SERVICE BULLETIN NO: NMD-53-10

TITLE: Fuselage - Additional Drain Holes in Stub Wing and Cabin Bottom Skin (Mod N629)

FUSELAGE, ADDITIONAL DRAIN HOLES IN STUB WING AND CABIN BOTTOM SKIN (MODIFICATION N629)

Position of Additional Drain Holes
Figure 1

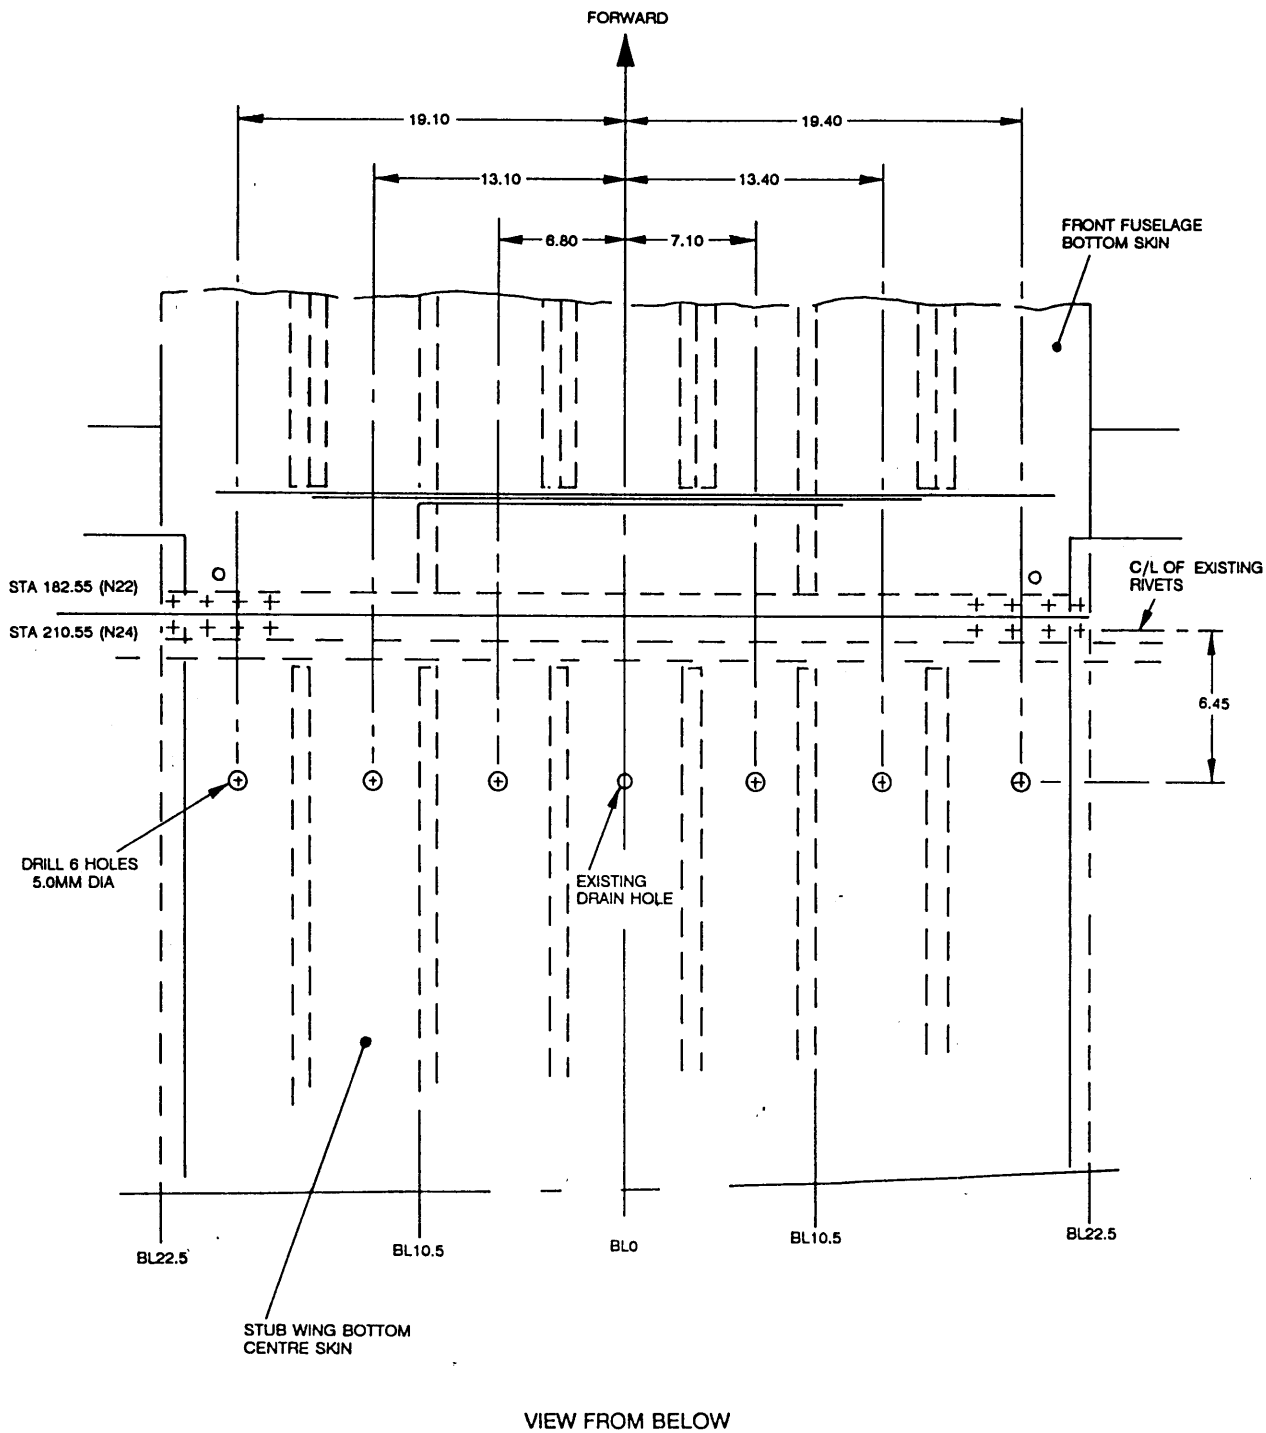
An additional six holes are drilled in the stub wing bottom centre skin.

- A. Referring to Figure 1, mark positions for six additional drain holes.
- B. Using a 5.0mm dia. drill, drill out the six holes. Deburr holes and clear all swarf from area.
- C. Touch up base metal with Alodine 1200S, epoxy prime and paint to suit aircraft colour scheme.
